# Planning Division Redlines 2/2/15

\* The above Please provide the following standards as required per LUC §108-1-2:

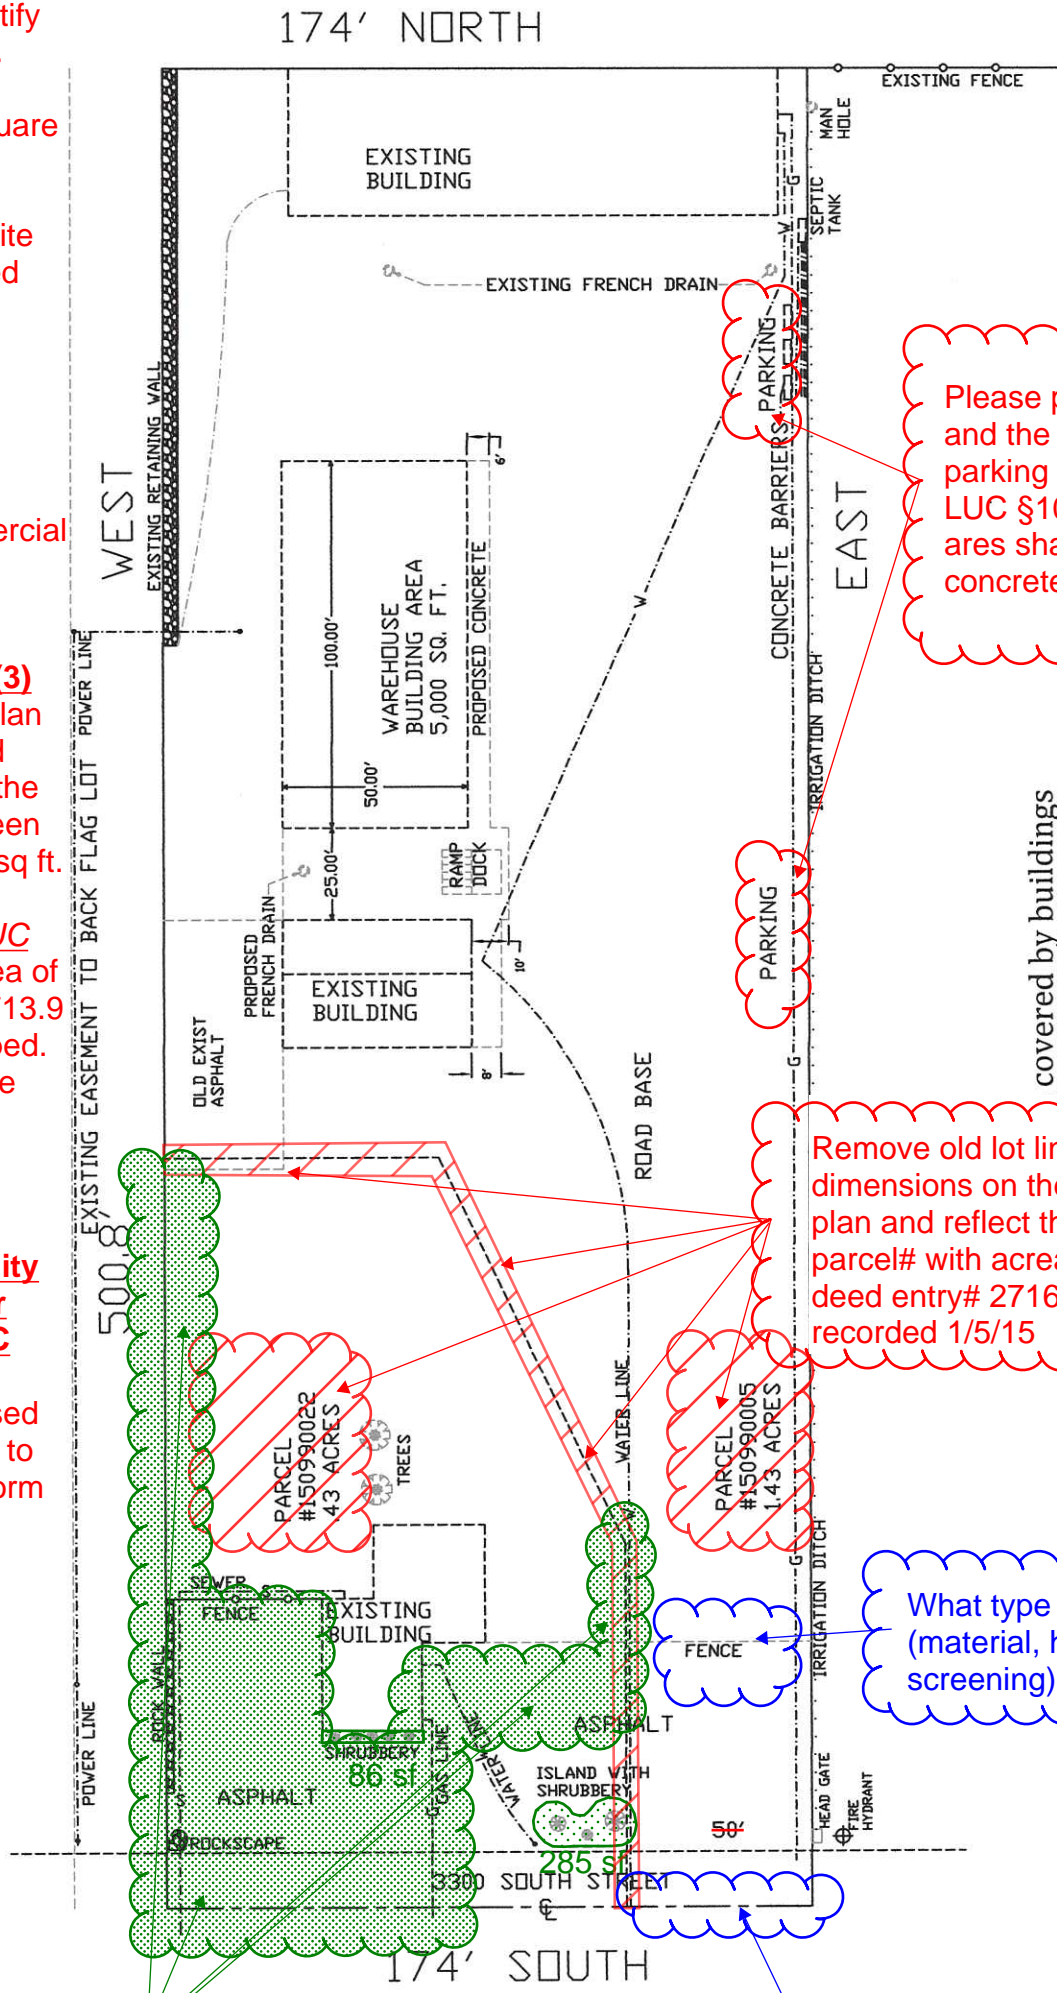
-Please provide details for all vehicle and pedestrian circulation on the site

-Please provide details on the site plan for all off-street parking including adequate parking for all clientèle and employees (you will need to identify how many employees you have). Adequate parking spaces shall encompass not less than 180 square feet of area and shall not be less than nine feet wide.

-Please provide details on the site plan for all lighting for the required off-street parking per

-Please provide any details for outdoor advertising in the commercial zone.

-Please provide a landscaping plan and details pertaining to new and existing landscaping. Based on the proposal, the landscaping has been calculated at approximately 393 sq ft. *All development/site plans must include 10% Landscaping per LUC §108-1-4(3).* Based on a site area of 87,139.2 sq ft, a minimum of 8,713.9 sq ft of the site must be landscaped. The landscaping plan needs to be detailed as identified in LUC 108-1-4(3) including an irrigation plan.

-The existing grades and proposed new grades need to be identified to ensure adequate drainage for storm water

Please provide the required parking and the required dimensions for the parking spaces per LUC §108-8 and LUC §108-1-4(1). All public parking areas shall be paved with an asphalt or concrete surface per LUC §108-8-7(b)

Remove old lot lines and dimensions on the site plan and reflect the new parcel# with acreage per deed entry# 2716792 recorded 1/5/15

What type of fence (material, height and screening)?

Consider this area for the landscaping as required in LUC §108-1-4(3)

Please label the access and/or driveway including the width and material.
